I wish to comment planning application HKP/2016/0128.

The image shows the proposed location of the house and entrance

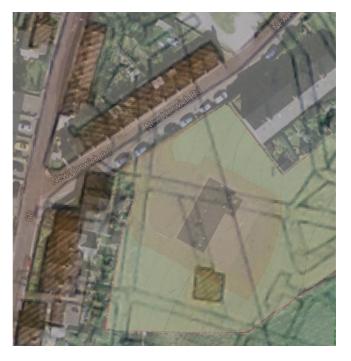
The applicant does not mention any mining survey of the site.

When these are superimposed (right), it can be seen that there are mine workings both under the proposed location of the house, and the access point from New Horwich Road.

If permission were to be granted for development of this site, given the very weight of construction traffic and earth moving machinery which would be required to remove very significant quantities of earth from the site, I hope that a full mining survey would be required by the planning authority before any development were to be permitted.
